McLaren Elva Door to Hinge Bolt Relaxation

Bulletin type:	Service Campaign
Campaign reference:	SCB 26 A 005
Attention:	Retailer Aftersales Managers, Retailer Service Managers, Retailer Service Advisors, Retailer Technicians, Retailer Parts Managers
Affected vehicles:	McLaren Elva – Specified VINs
Situation:	Hinge to door bolts require replacement
Procedure:	Action affected vehicles during next Retailer visit. Please refer to the information outlined in this document to complete the checks required
Date:	16 th June 2022

Image 1 – Location of the three door to hinge bolts

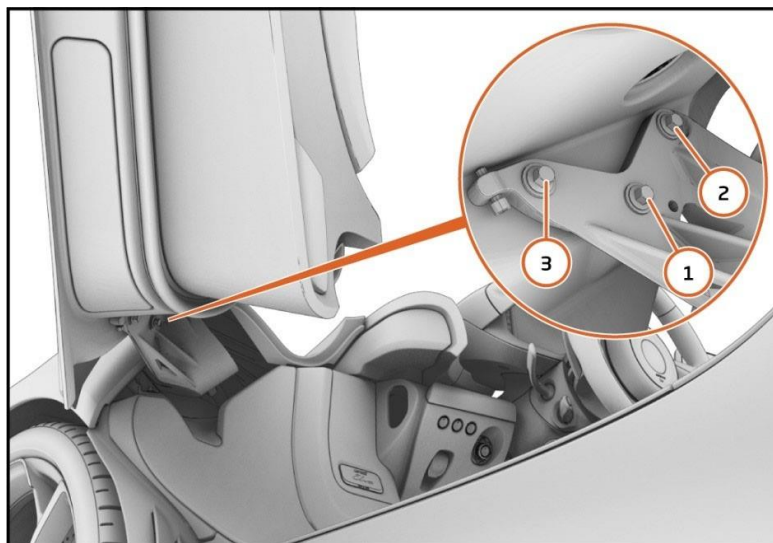
Through continuous product quality monitoring, McLaren Automotive has identified that on a specific number of McLaren Elva vehicles the door to hinge bolts on both driver and passenger doors may experience torque relaxation. Over an extended period of time, degradation of door gap and flush and potential clashing of the door striker to the latch surrounding may occur. To address this, McLaren has released a solution which includes the fitment of a longer bolt variant (three bolts per door hinge) following a specific torque up sequence.

PART NUMBER	PART DESCRIPTION	QUANTITY REQUIRED
00RA819	Bolt – M8x50	6
00RC048	Washer – M8	6
